TRE-APP-APP21-38801349 - PLAT 19-11800359 RUBY CROSSING UNIT 1

```
***SCOPE OF WORK: PLATTING AND TREE REMOVAL FOR RESIDENTIAL DEVELOPMENT***

***MASTER TREE PLAN FOR RUBY CROSSING UNITS 1, 2 & 3***

// TECHNICAL REVIEW COMMENTS // HG 7.24.2020 //

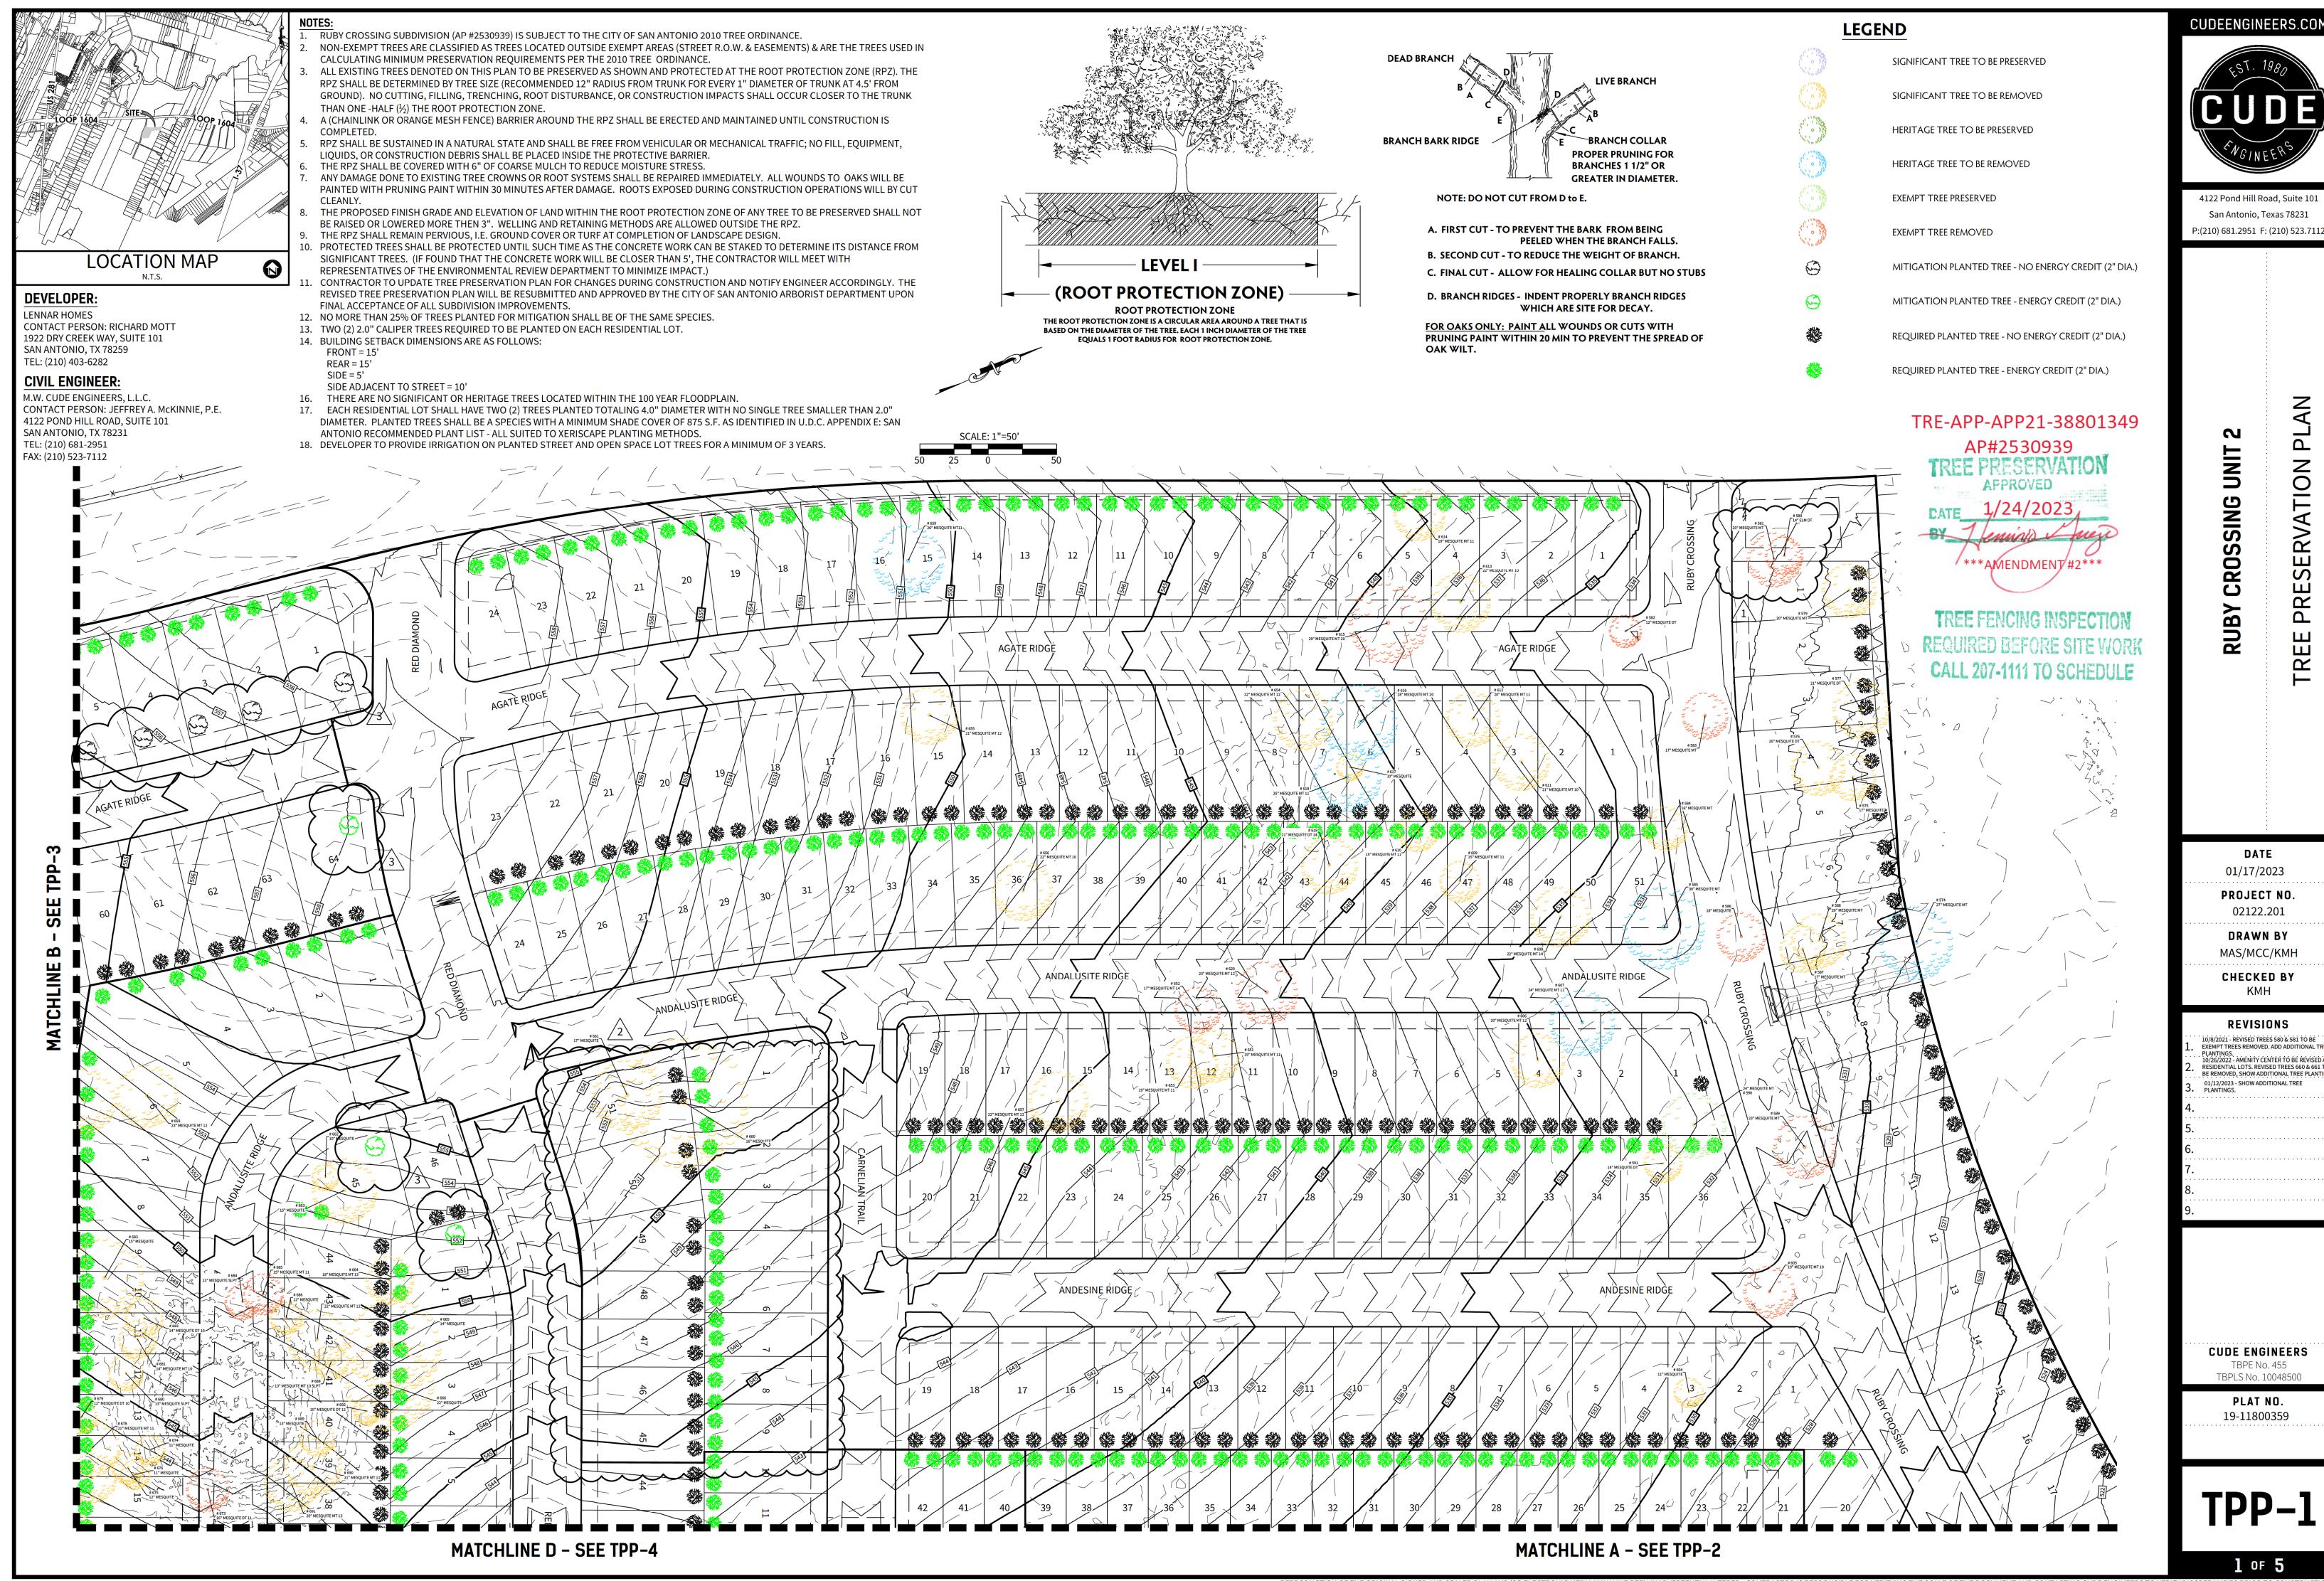
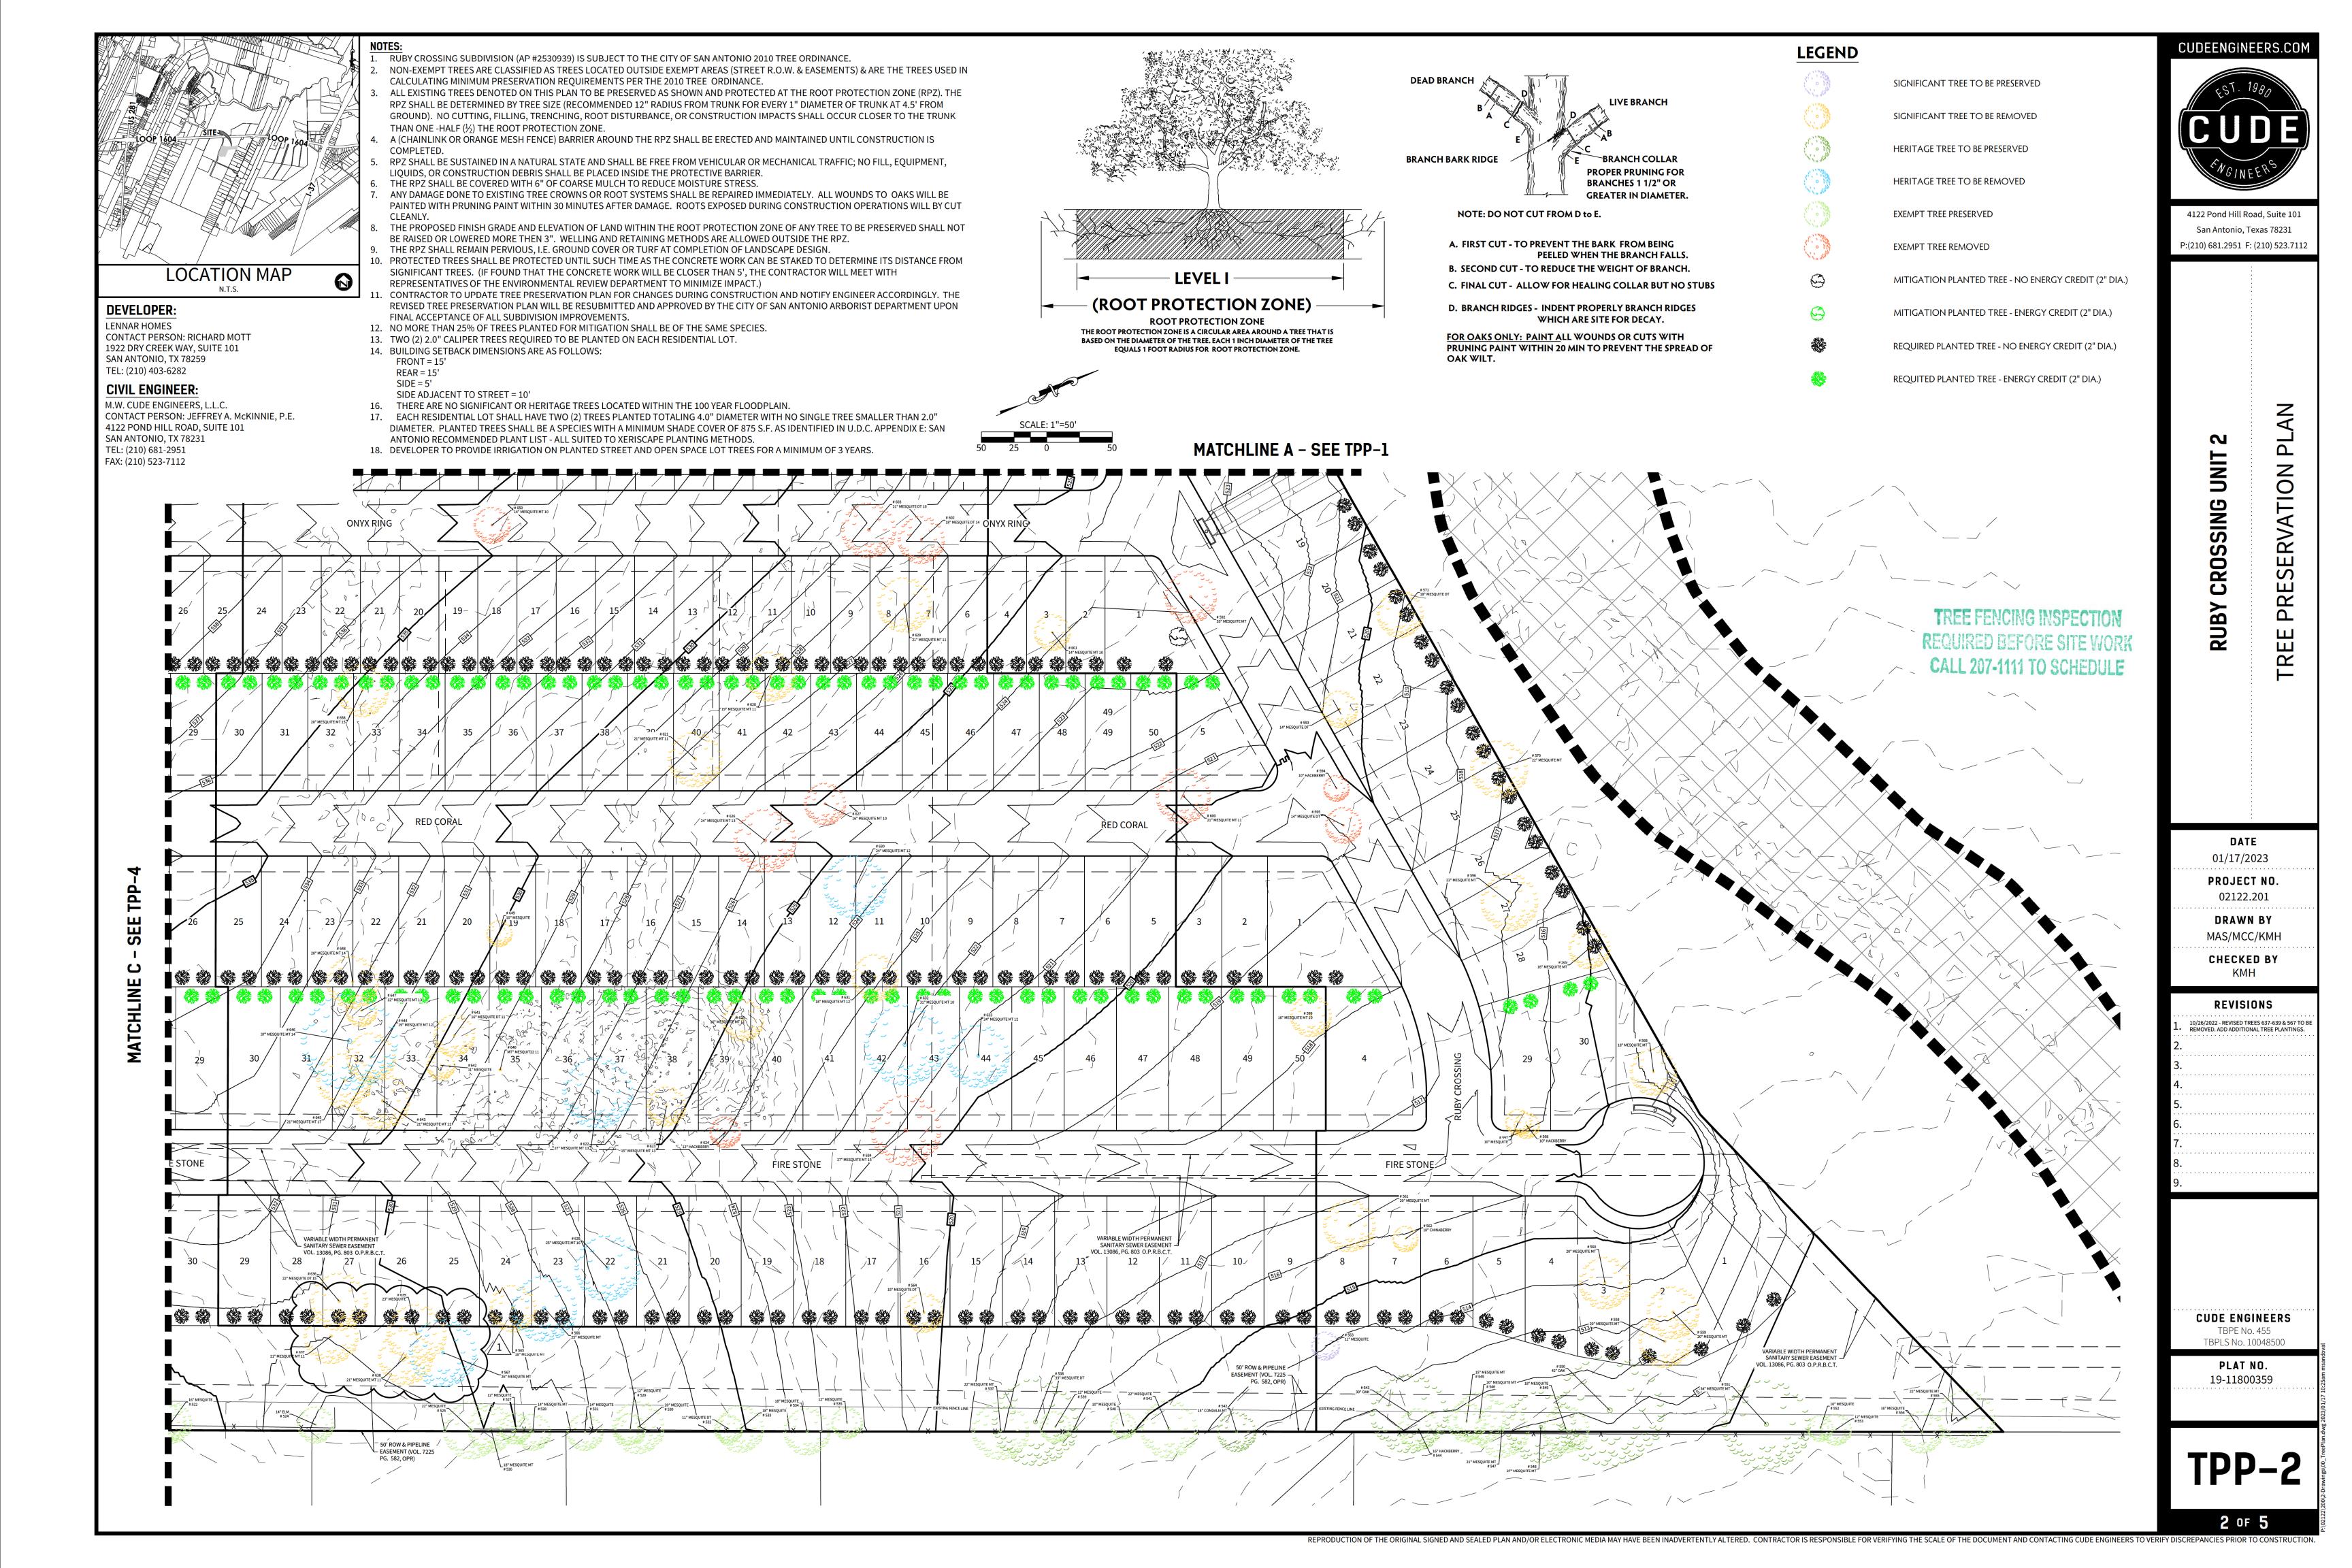
- -(2)-2" CALIPER NATIVE MEDIUM TO LARGE SHADE TREES REQUIRED PER 516 LOTS AT BUILDING STAGE FOR MITIGATION AND TREE CANOPY COVER REQUIREMENTS.
- -(3)-2" CALIPER NATIVE MEDIUM TO LARGE SHADE TREES REQUIRED PER 65 LOTS AT BUILDING STAGE FOR MITIGATION AND TREE CANOPY COVER REQUIREMENTS. SEE APPROVED TREE PLAN FOR LOTS TO RECEIVE 3 TREES PER LOT.

// NOTE: APPLICATION IS FOR PLATTING, SITE WORK AND TREE REMOVAL PURPOSES. TREE REVIEW APPROVAL IS FOR TREE REMOVAL WITHIN UNIT 1 ONLY. ANY SITE WORK OR TREE REMOVAL OUTSIDE OF UNIT 1 SHALL REQUIRE A SEPARATE TREE APPLICATION BE SUBMITTED AND APPROVED PRIOR TO START OF WORK.

A DO NOT RECORD IS PLACED ON THIS PLAT. THE APPLICANT/OWNER IS RESPONSIBLE FOR SCHEDULING A TREE FINAL INSPECTION PRIOR TO PLAT RECORDATION TO ENSURE THE PROJECT MEETS THE TERMS AND CONDITIONS OF APPROVAL PER 35-523. CALL 210.207.1111 AND REFERENCE AP#2530939.
